**HISTORIC PRESERVATION REVIEW BOARD
STAFF REPORT AND RECOMMENDATION**

Landmark/District:	Anacostia Historic District	(x) Agenda
Address:	1321-1325 Maple View Place SE	
Meeting Date:	February 2, 2017	(x) New construction
Case Number:	17-129	(x) Subdivision
Staff Reviewer:	Tim Dennée	(x) Concept

The applicant, property owner Chughtai Family Properties LLC (with architect Stephen duPont), requests the Board's review of a concept to subdivide two lots (976 and 877 in Square 5803) into four lots of record and to build upon them four two-story frame houses, each with an accessory apartment in the basement.

A 1904 Sanborn insurance map detail depicting “137” Maple View Place, which stood on the present parcel until the 1970s. “127” is the present 1319 Maple View, “147” is 1333. “141” was also demolished in the 1970s and was later replaced by the present 1327 Maple View.

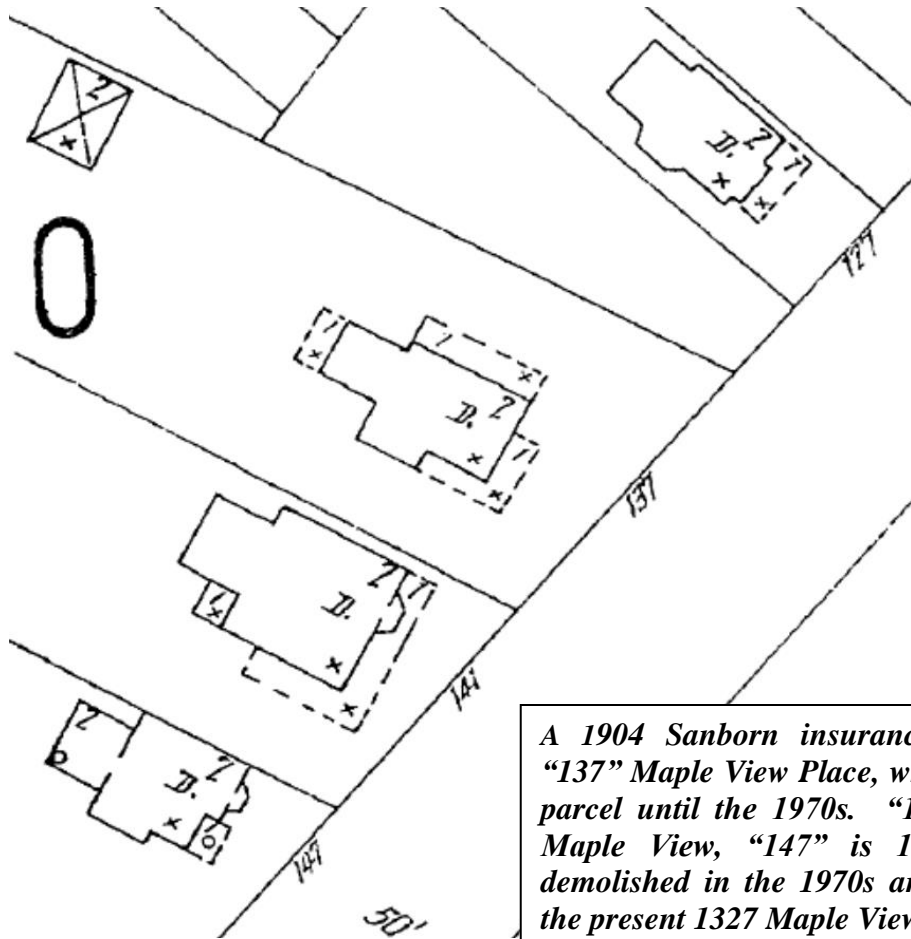
Among the guidelines' principles of compatibility is that new buildings should respect the rhythm of their neighbors as well as that of the street. The presence of these vacant lots next to a noncontributing building allows some flexibility to re-establish a rhythm, not necessarily replicating the historic condition, but taking cues from groupings of homes on the street.

The original (1886) subdivisions and early resubdivisions of Griswold’s Addition do not provide much guidance, as the lots were most often about 25 feet wide, although some were as little as 20 feet, and others slightly more than 30. In this particular location, a larger parcel was further subdivided in 1894 and 1903. 1319 Maple View and the houses to its west were placed on 22-foot-wide lots, although 1317 straddles two such lots. The land overlapping the subject lots were left large—40, 60 and 75 feet—and then resubdivided to their present extent when 1327 was built in 1991.
